### 10.3 Main Steam Supply System

The information in this subsection of the reference ABWR DCD, including all subsections, tables, and figures, is incorporated by reference with the following departures and supplements.

Figure 10.3-1 Main Steam Supply System

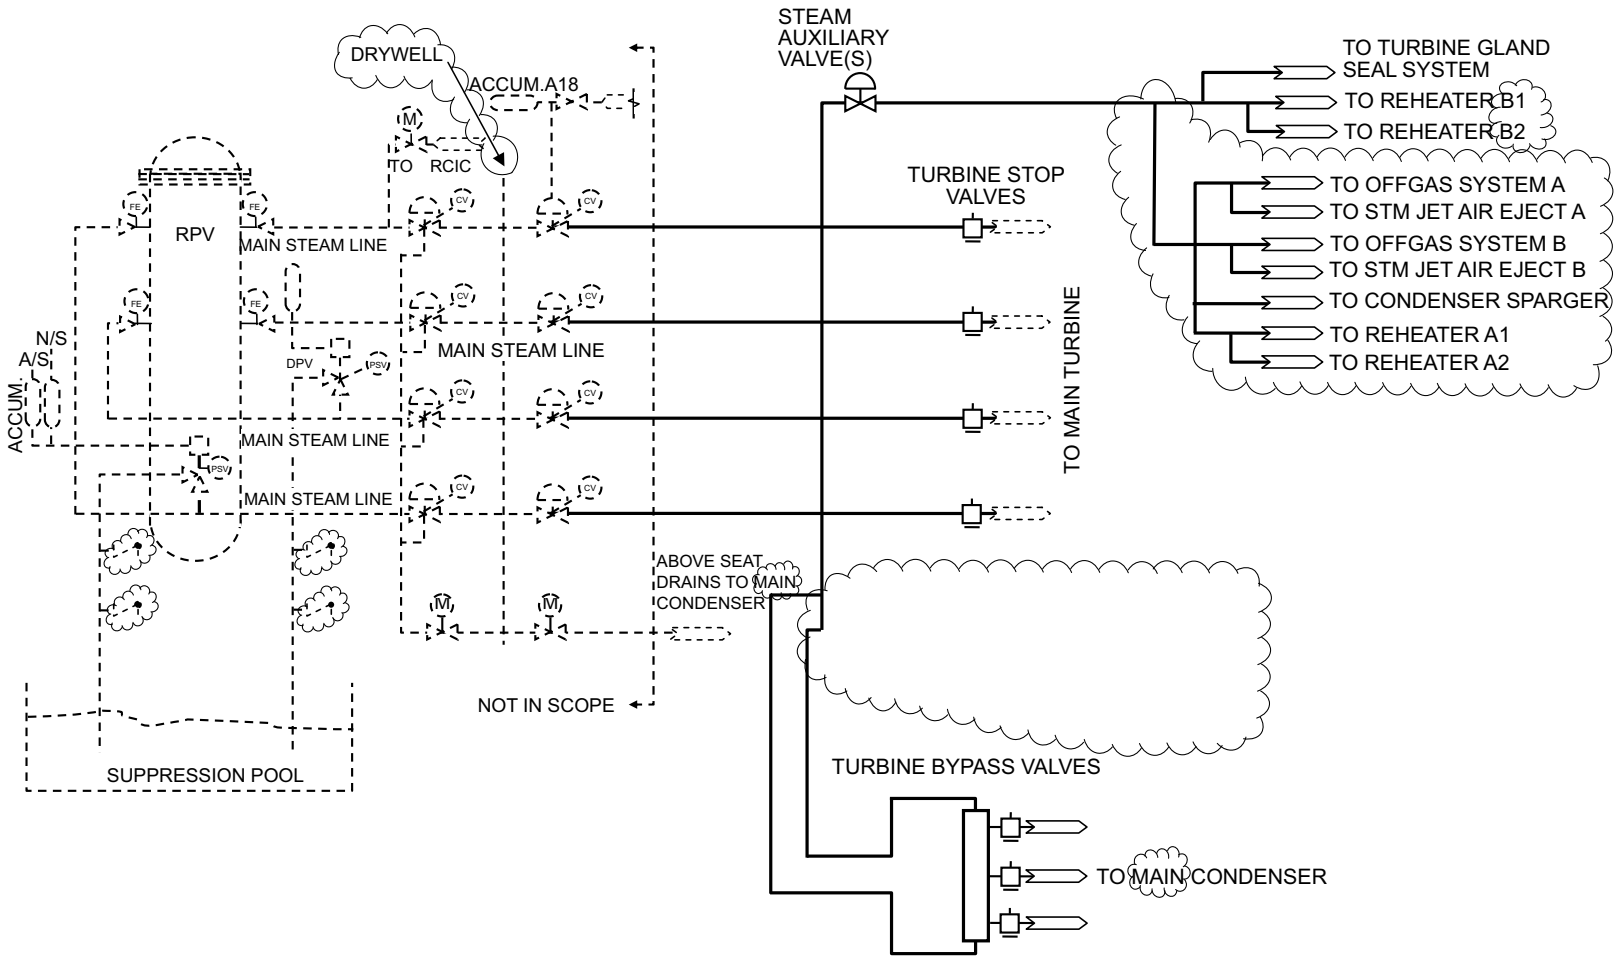
STP DEP 10.2-1 (Table 10.3-1, Figures 10.3-1 and 10.3-2)

Figure 10.3-2 Main Steam Turbine System

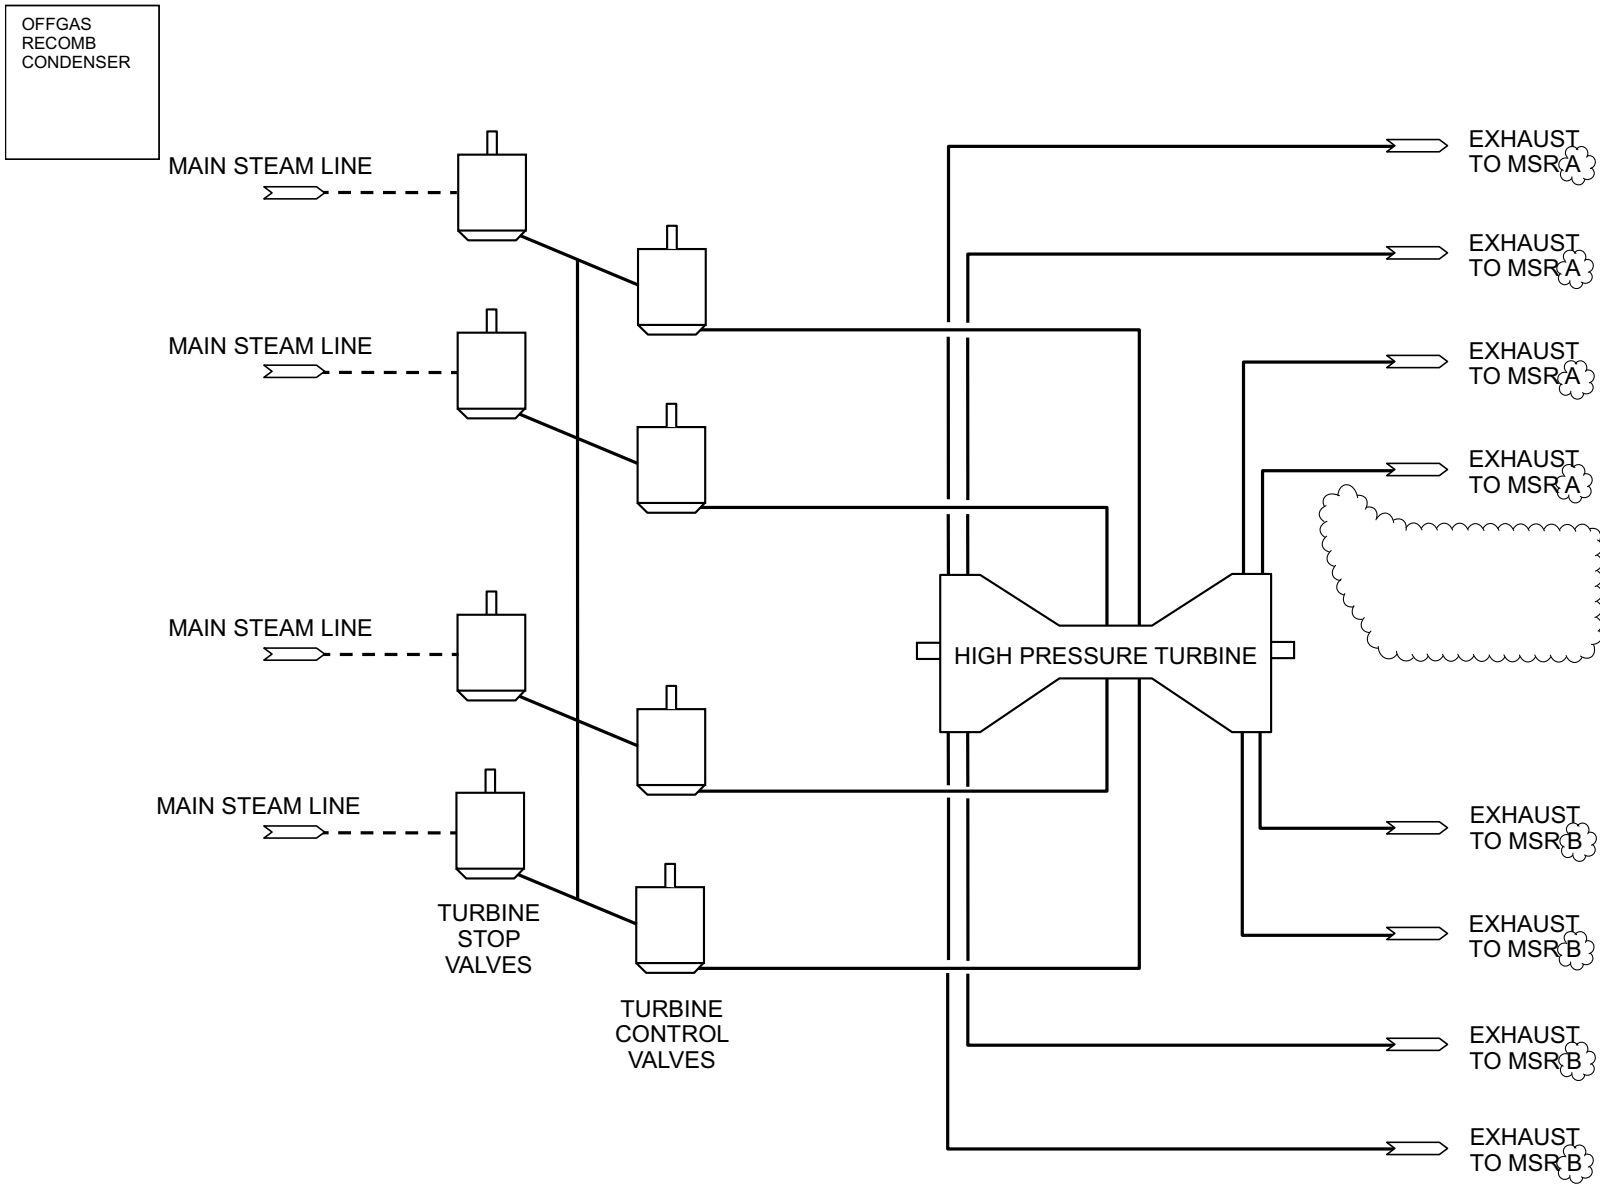
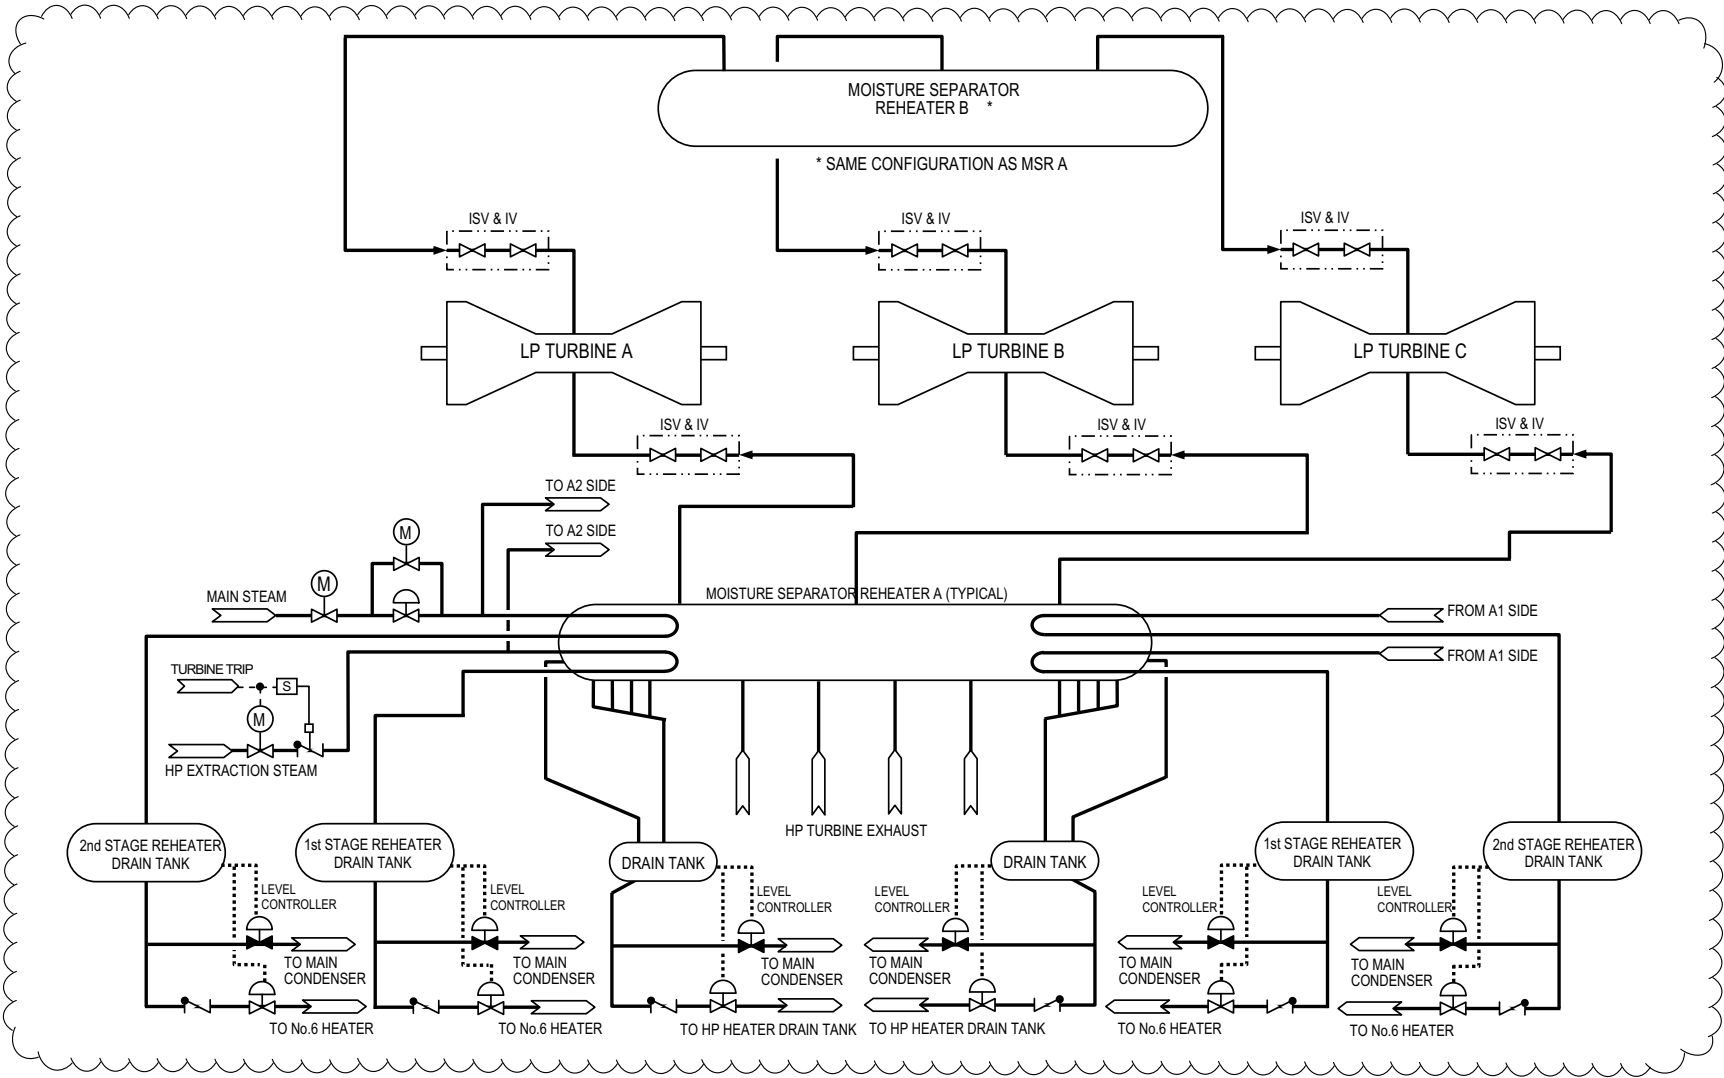
STP DEP 10.4-3 (Figure 10.3-2)
